6.0      WATERWAYS EXPERIMENT STATION REPORT: LOCKPORT POWER  
PLANT SLUICE GATE AND CONTROLLING WORKS DISCHARGE  
EVALUATION

## 6.2 WATERWAYS EXPERIMENT STATION REPORT

### 6.3 TECHNICAL COMMITTEE FINDINGS

FIGURE 6.1

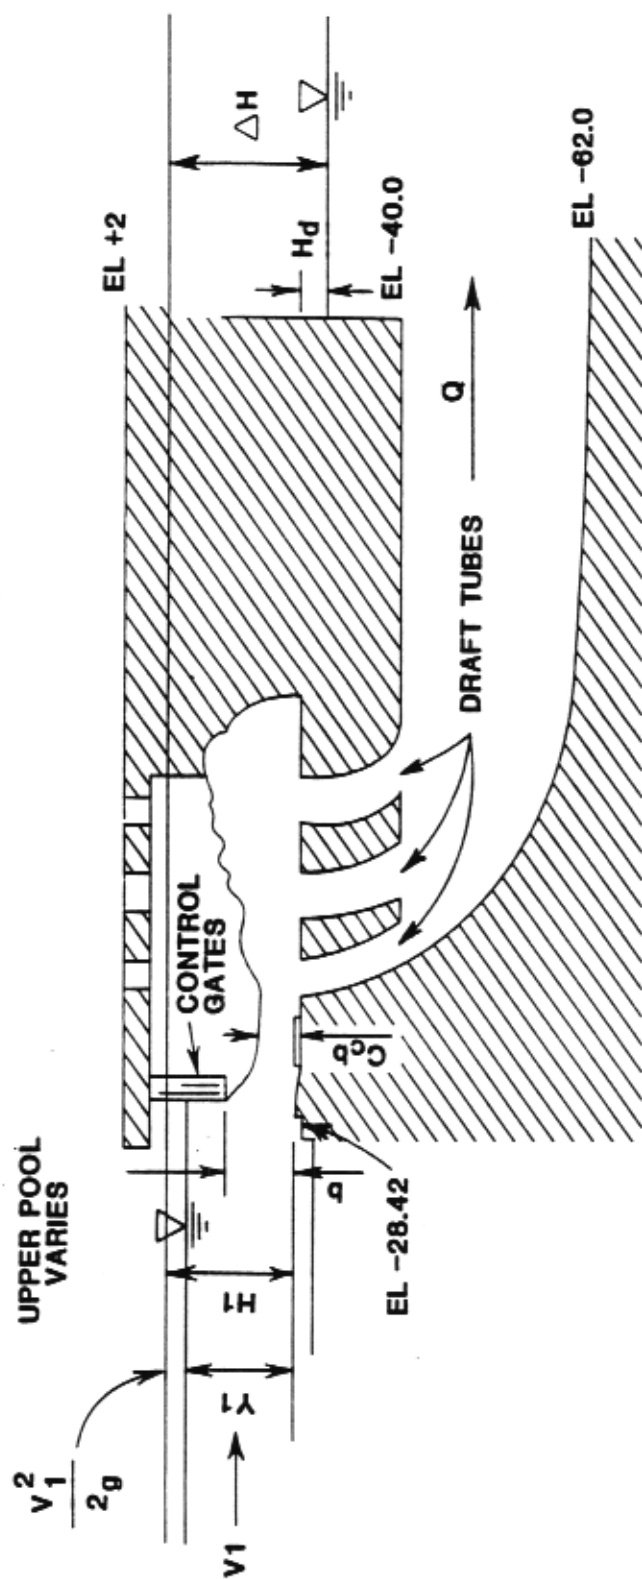
Referring to Figure 6.1

$$\Delta H = H_1 + H_d$$

where  $H_d$  = draft head, -28.42 - T.W., and

$$C^1 = C \sqrt{H_1} / (H_1 + H_d) \quad 6.2$$

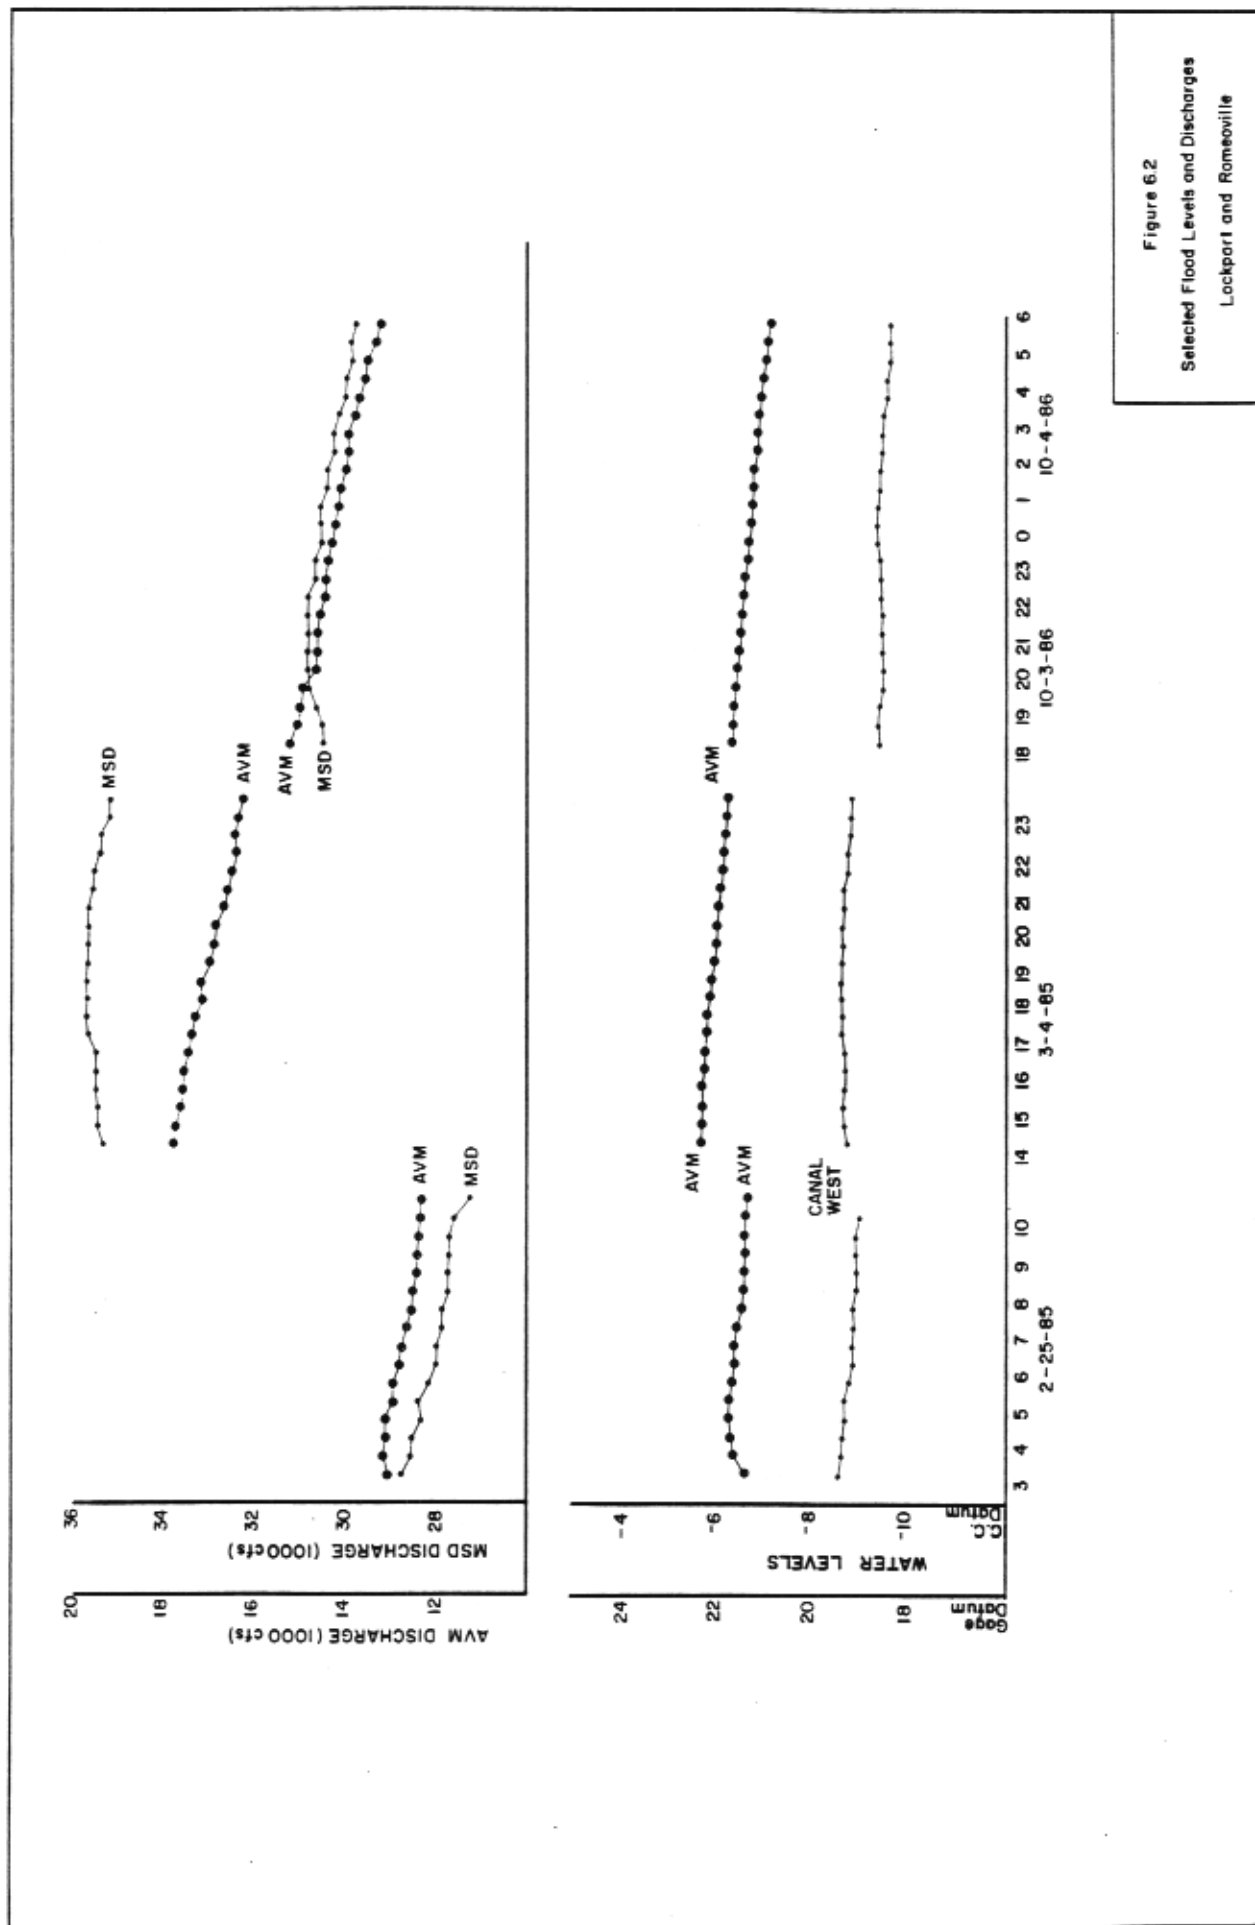
examination of the MSD Lockport and AVM records for these dates (Figure 6.2) tend to support the argument that the discharge ratings for the Powerhouse sluice gates may not be adequately represented by the model study.

Water stages and discharges for February 25 and March 4, 1985 and October 3-4, 1986 are also plotted in Figure 6.2. The plotted data are taken directly from the Lockport Powerhouse log sheets and the AVM printout.

Figure 6.3  
Plan View of  
Controlling Works

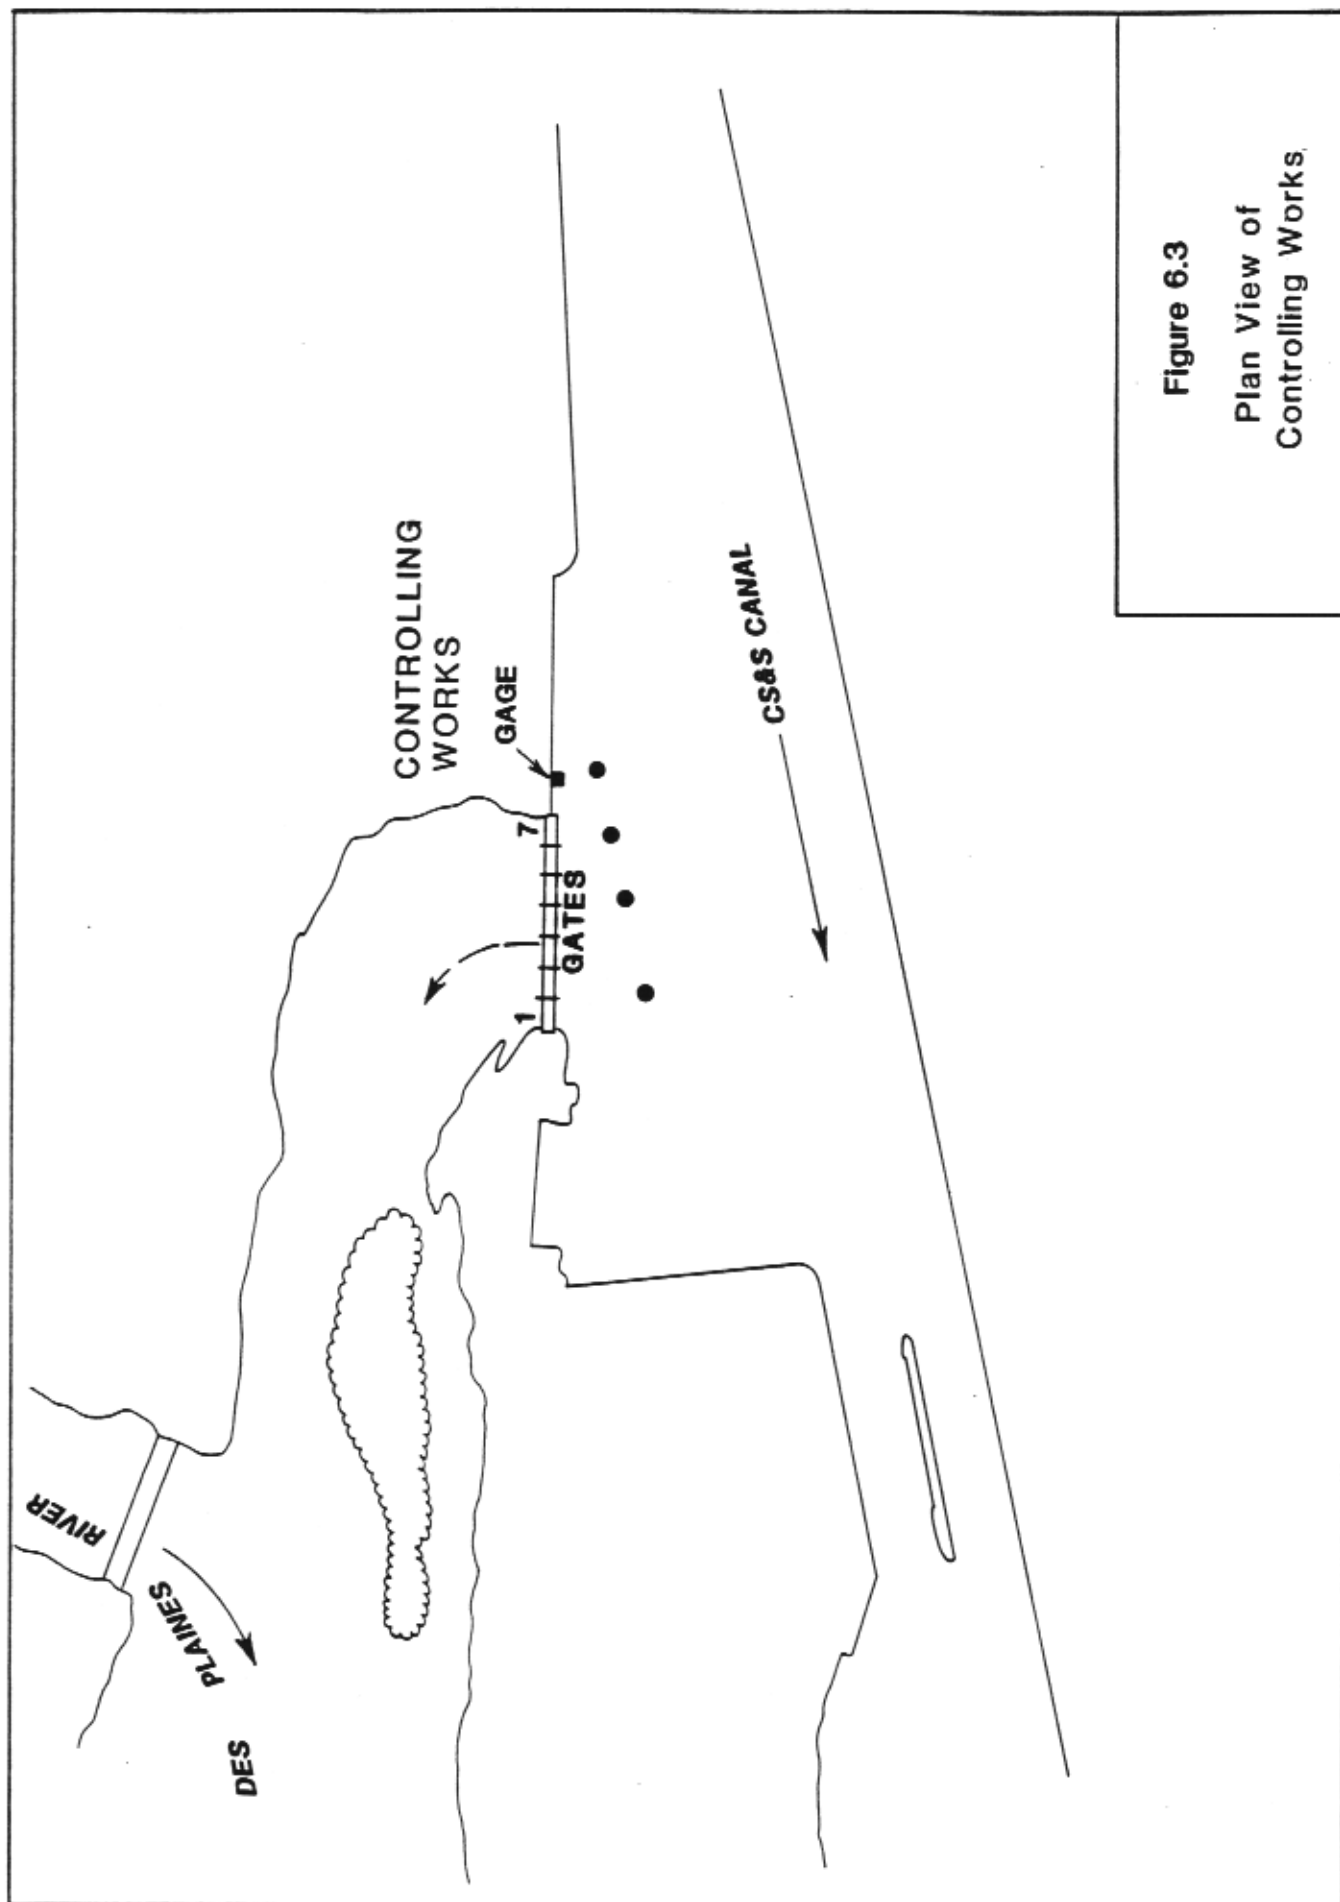
The four 30-ft diameter mooring piers (see Figure 6.3) were judged to have some influence on flow through the Controlling Works gates. This influence was expressed in terms of the velocity-head computed for the approach to the gates, and to account for head loss at pier no. 3 for the computation of flow through gates nos. 6 and 7.

- (2) Nevertheless there is some basis for suspecting that the mooring piers, together with other site considerations, may have a greater flow-inhibiting effect than would be expected otherwise. For example:
  - (a) During floods there is likely to be a concentration of flow with significant velocity along the levee approaching the north end of the structure (gate 7). From this direction the mooring piers could represent a formidable obstruction to flow.
  - (b) Ignoring the mooring piers for the moment, with any reasonable concentration of flow along the canal levee from the north, the structure is somewhat analogous to a constricted section with a large contraction ratio that is near fully eccentric. This would be particularly true if downstream

submergence existed. Under these conditions the no. 6 and 7 gates could well be "outside" the live contracted zone, and it would not be unusual for flow through gates 6 and 7 to be relatively small. For comparable bridge constrictions (with subcritical flow) there have been many observations where flow in the "6 and 7" bents, or openings, were found to be zero or even negative. The presence of obstructions such as mooring piers would tend to limit the access of flow to this area even more.

- (c) The discharge channel connecting the downstream side of the Controlling Works with the Des Plaines River turns immediately to the left almost parallel to the canal. This, together with the probable influence of the mooring piers, gives cause to suspect more fall across the south abutment than the north abutment.
